CHANGE ORDER FORM

Change Order 3

Date of Issuance: 3/16/2020	Effective Date: 3/16/2020
Owner: WSFC Utilities	Owner's Contract No.:
Contractor: D.H. Griffin Infrastructure	Contractor's Project No.: 19-20-1310
Engineer: HIGHFILL Infrastructure Engineering, P.C.	Engineer's Project No.: WIN1702
Project: Idols Rd Regional Lift Station	Contract Name: Idols Rd. Regional Lift Station

Change Order for Installation of Power Conduits and Related Items
Idols Road Regional LS
February 11, 2020
HIGHFILL Project No. WIN1702

FIGURE A
NTS
1/24/2020

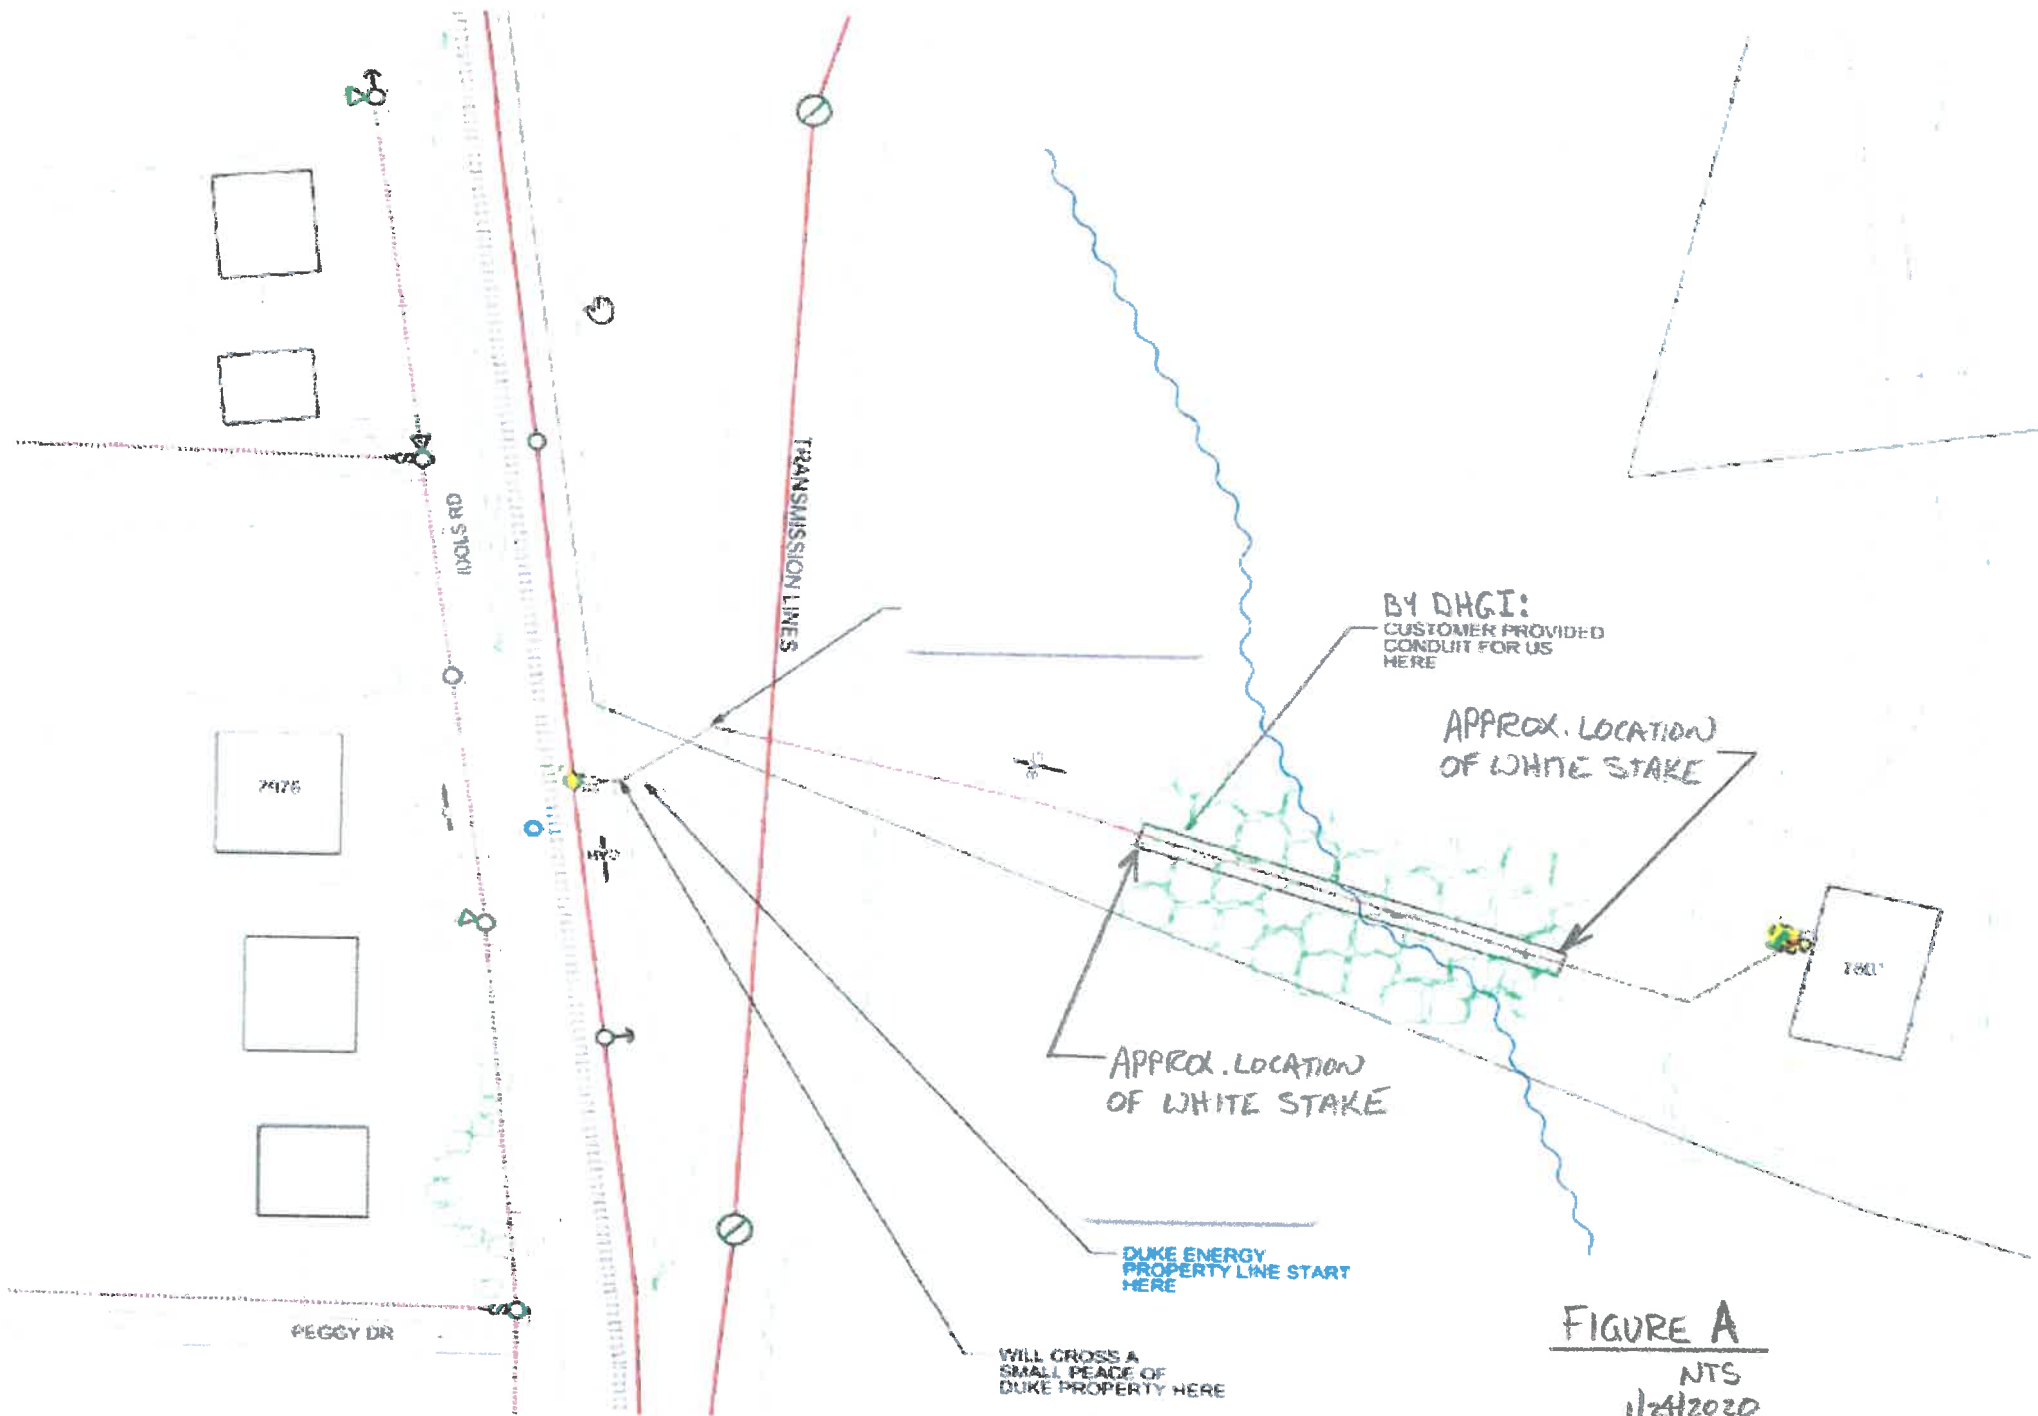
Install 2 runs of 4-inch diameter power conduit between the two white stakes annotated on Figure A, attached. The horizontal distance is 250 feet between the stakes. The conduits installed shall extend 10 feet beyond each stake (270 linear feet total) No conduit turns, horizontal nor vertical, shall exceed 45-degrees.

The ditch crossing is a regulated blue line stream; therefore, the installation shall be by Horizontal Directional Drill. Contractor has the option to drill the conduits individually or drill one larger conduit and install two 4" conduits inside the larger one. Leave each end of conduits sticking up 3-5 feet above grade to identify the location for Duke Power's connection to their installation.

Entry and exit angles shall allow for connection of conduits by Duke Power's open cut trenches at a depth of 36" to 48" of cover. Contractor shall design the HDD pipe wall thickness for depth of installation, HDD operations including pipe pull-back and fusing design. The drilled pipe shall be HDPE or fusible PVC. The drill path shall be a straight line between the stakes to remain within the Duke Power easement.

FIGURE B

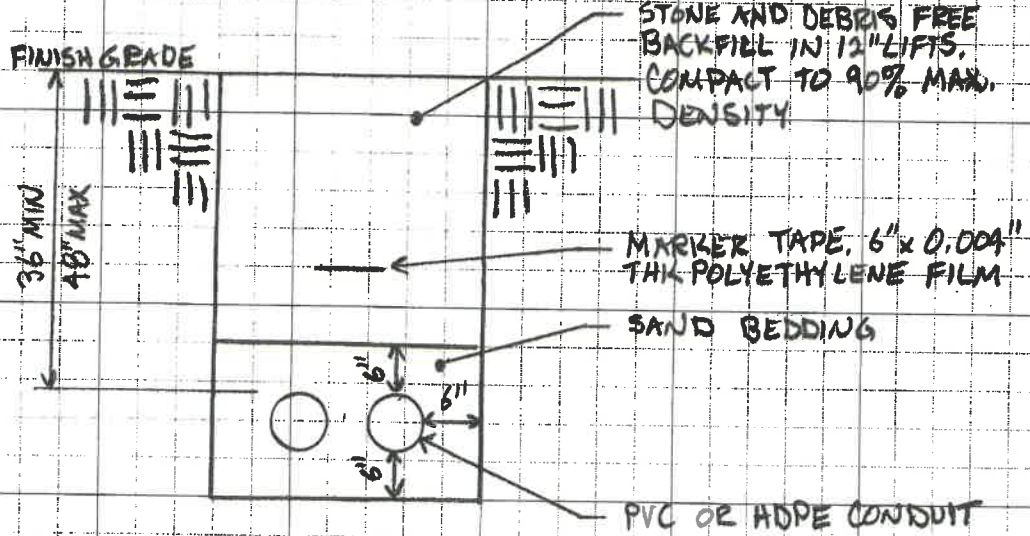
- As it pertains to installation depth [by open cut], the conduit shall be a minimum of **36 inches** deep (measured from grade to top of conduit) to a maximum of **48 inches** deep along all sections of the installation. The depth of the conduit installation where the conduit will physically reside underneath the stream bed will also need to comply with the minimum/maximum stated earlier.

FIGURE D
1/24/2020

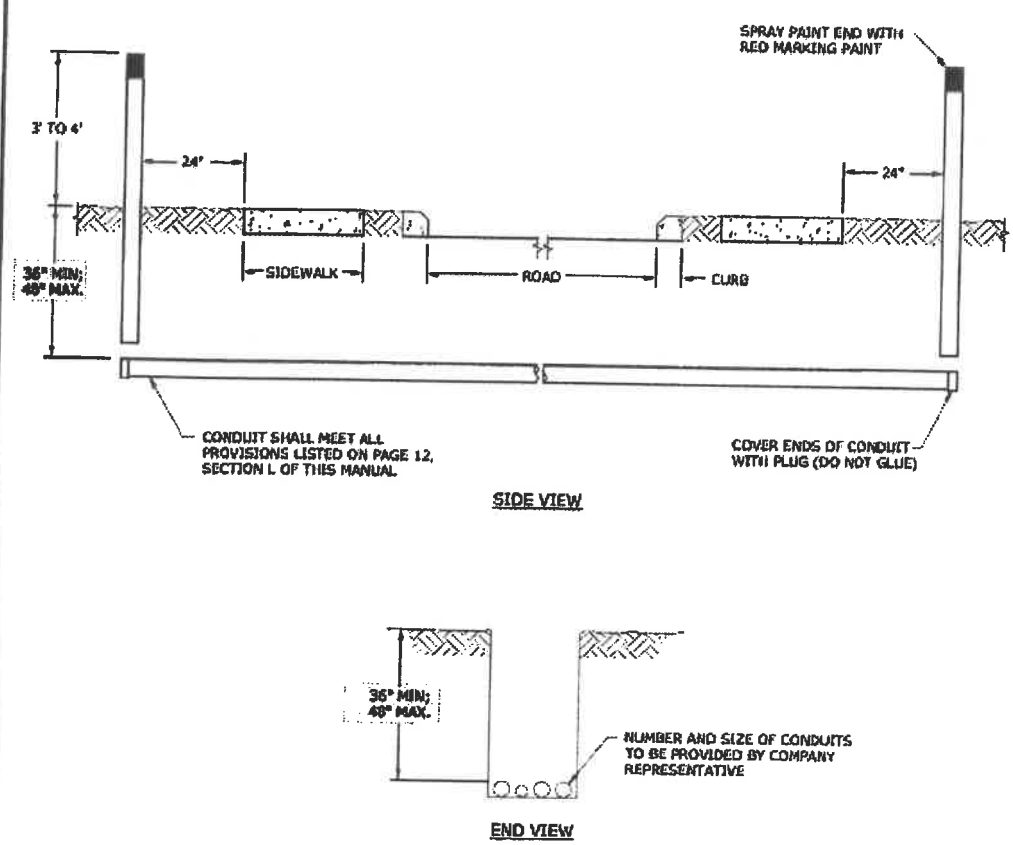
- The “*ConduitCrossing-SvcReqmtManual*” document is a visual reference for the conduit installation, regardless of the obstacle being crossed in most cases. The primary take away from this document are the specifics surrounding the **conduit marking, pull string, end encapsulation, and minimum depths**. [Figure D, attached]
